CAMPAIGN BULLETIN

01-593-11

Models Affected: Aerial and Digger Derricks

SUBJECT: Miller "D" lanyard anchor p/n 472452

Date code

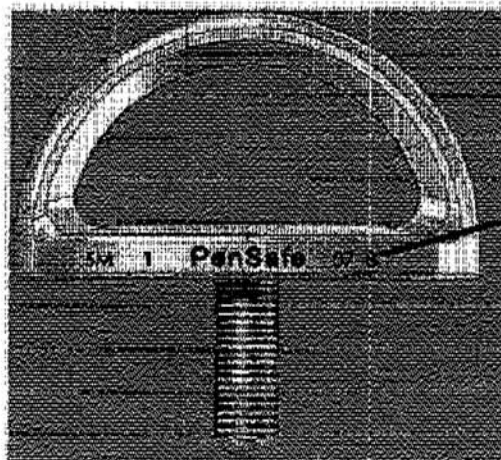
TEREX Utilities has received notice of a recall from the supplier of the D shaped lanyard anchor, p/n 472452 with the date code 07B. There is a deficiency in the material strength that may cause the threads on the stem to fracture prematurely. These parts could be on machines built from June, 2008 through November, 2010.

During a fall arrest event the D shaped lanyard anchor can fail.

Immediately inspect the lanyard anchors on units listed in the attached letter for lanyard anchors having the date code 07B, as shown below. Immediately take the unit out of service if the date code appears. If the date code does not appear, simply complete the enclosed form to complete this bulletin.

If your lanyard anchor is affected, call TEREX Utilities, at 605-884-3892 for a replacement kit, p/n Z-1200. Follow the installation instructions that accompany the kit. Complete the enclosed form and return it with the affected anchor to TEREX Utilities, using the shipping label and shipping box, for credit.
